**DEPARTMENT OF TRANSPORTATION  
STATE OF GEORGIA**

**FILE:** BHFST-0001-05(024) Cobb Fulton                      **OFFICE:** Engineering Services  
 CSSTP-0009-00(410)  
 P.I. Nos.: 720125 0009410  
 SR 3/US 41: Northgate Dr. to Paces Mill Rd.    **DATE:** September 28, 2009

**SUBJECT: IMPLEMENTATION OF VALUE ENGINEERING STUDY ALTERNATIVES**

Re: Response to Value Engineering Recommendations  
US 41 over the Chattahoochee River  
BHFST-0001-05(024), Cobb & Fulton Counties  
P.I. No. 720125

## Alternative B-1

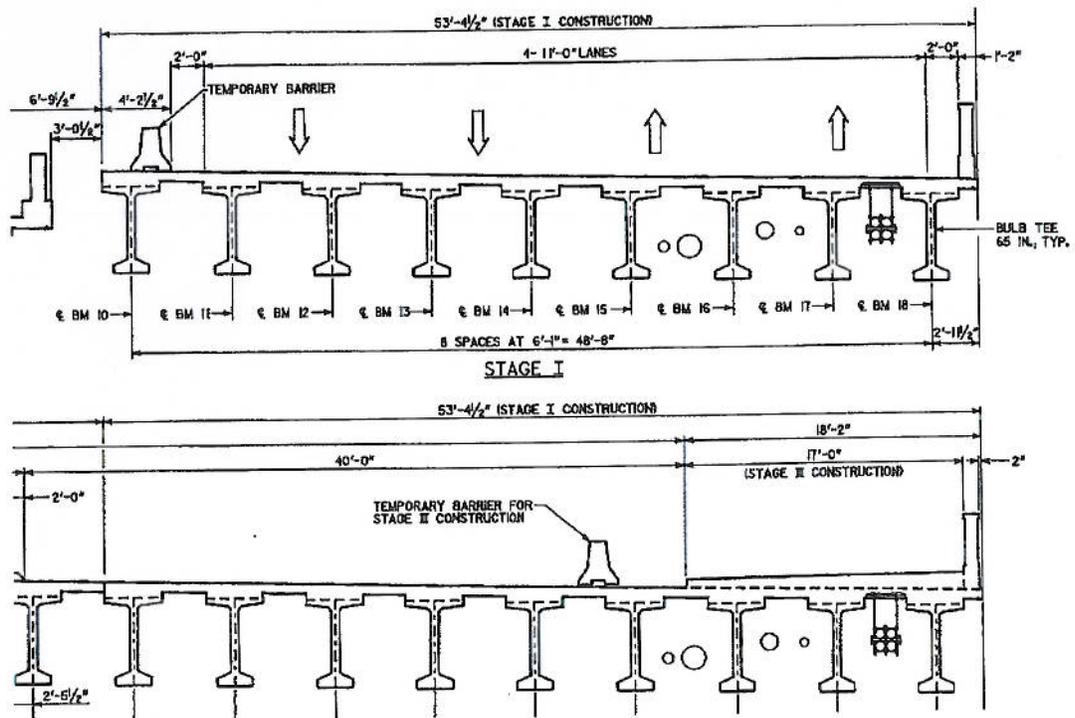
Description: Respace the beams for the river bridge to use fewer beams and use 72 in bulb-T beams in lieu of 65 in bulb-T beams.

Cost savings: \$249,041 (MA estimated cost savings: \$9,639 CST - \$96,000 DES = -\$86,361)

Response: By our calculations, the cost savings in using 14 - 72 inch bulb-T (BT) beams versus the 18 - 65 in BT beams options would be only \$9,639 (see attached). Items that affected this estimate include:

1. A beam analysis of the VE proposed 8-1 1/2" beam spacing was run and final concrete strength of 10K is required.
2. The weights of the Edge beams, Endwalls, and Diaphragms were added.
3. A 10% premium (per precaster) increase in the unit cost of the BT 72 beams was added since they will require concrete release strength of higher than 8000 psi.
4. The additional costs of longitudinal and transverse bar were added.

Re-design of this bridge would delay the schedule by 4 months and would require an additional \$96,000 in design fees. Attached is a detailed breakdown of manhours for the estimated add'l design work.

Final Disposition: REJECT
